RE: PCN # ESU270-83 – AQ24CANFD-02HTG additional backend location approval

Prepared By : Light Hsieh-Product Engineering Supervisor,
Raider Chen-Product Engineer, Sophia Hu- Assistant Product Manager
Date : 2022/9/8
Device : AQ24CANFD-02HTG
Revision : A

Barcode Scanning Result

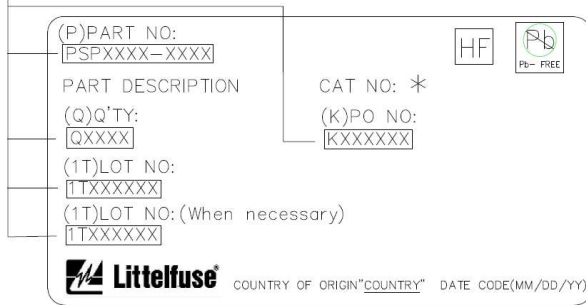
Both suppliers were qualified by Littelfuse and product can be identified by CAT NO on the label.
